MAINE TURNPIKE AUTHORITY

ADDENDUM NO. 1

CONTRACT 2019.09

BRIDGE IMPROVEMENTS
MAINE CENTRAL RAILROAD OVERPASS
MILE 47.9

SHEET NUMBER: S-41
CONTRACT: 2019.09
92 OF 116

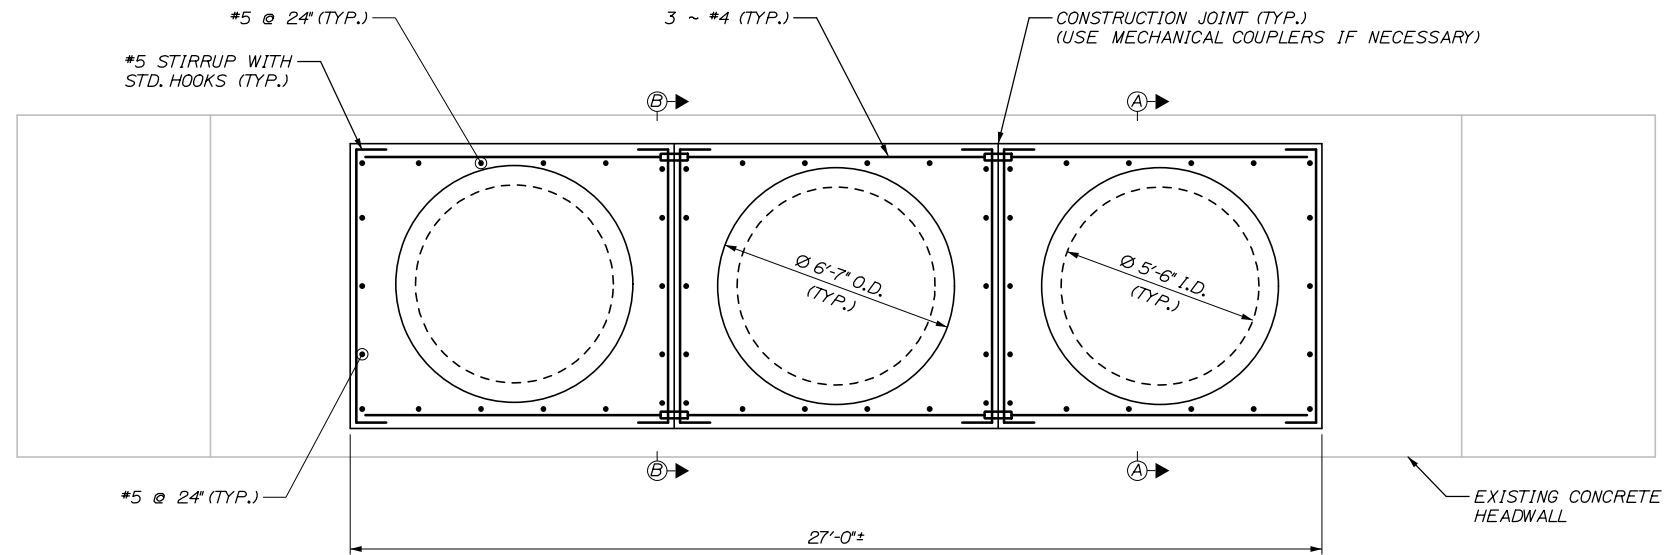
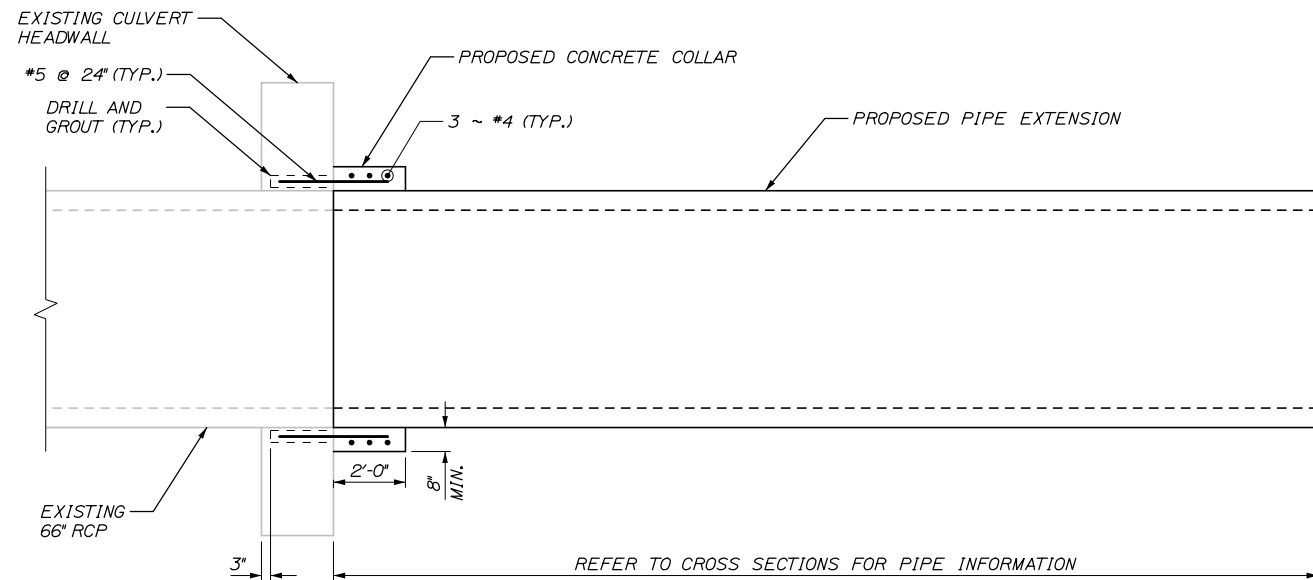
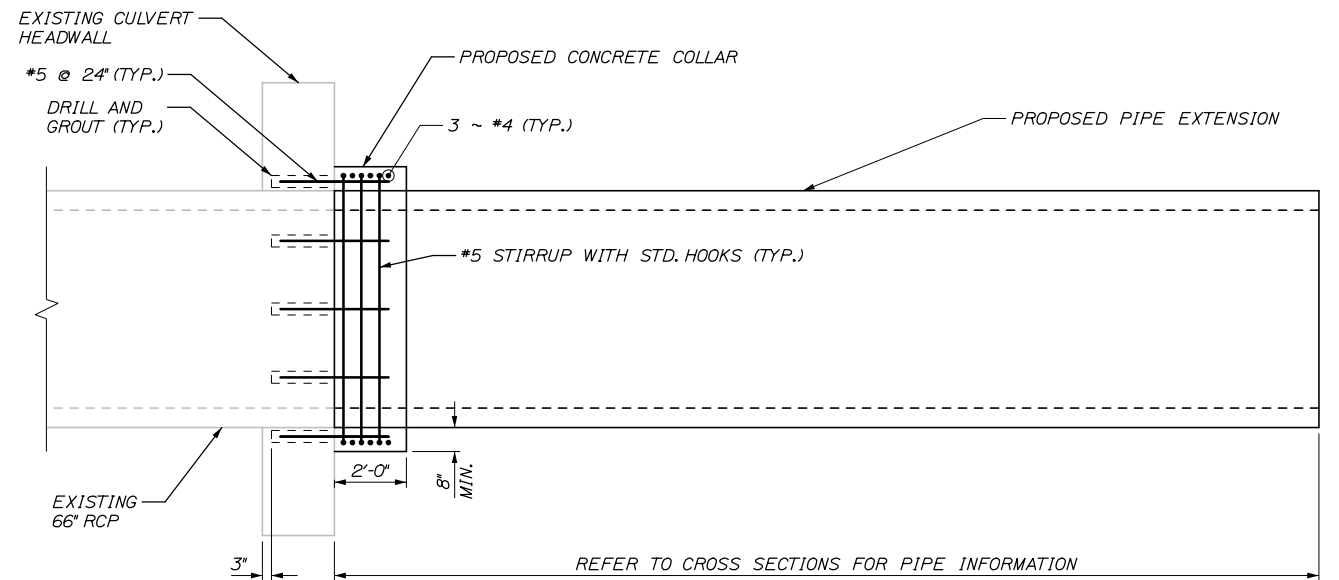
9. MAINE CENTRAL RAILROAD PART II, Plan Sheet S-01, sheet 52 of 116 “General Notes, Index, Quantities”: This plan sheet is removed in its entirety and replaced with the attached revised sheet 52.
10. MAINE CENTRAL RAILROAD PART II, Plan Sheets S-40 through S-42, sheets 91 through 93 of 116 “Fore River Culvert I through III”: These plan sheets are removed in their entirety and replaced with the attached revised sheet 91 through 93.

Answer: The sheet pile wall shown on the Plans is deleted. In lieu of installing a sheet pile wall system the Contractor shall extend the existing Fore River culverts as shown on the revised plan sheets. Note that this work will not be allowed to occur until after approved permits are received from MaineDEP and the U.S. Army Corps of Engineers. These permits are expected to be received on or before July 2019. Additionally, all work related to the culvert extensions shall be completed during the designated in-stream work windows defined in Special Provision 107.4.6, Prosecution of Work.

This work also consists of furnishing and installing a concrete collar to join the existing Fore River Culvert concrete headwall to the proposed pipe extensions in accordance with the details as shown on the Plans. The Contractor shall note that the concrete headwall and existing pipe ends may be of different sizes and may not fit snugly together.
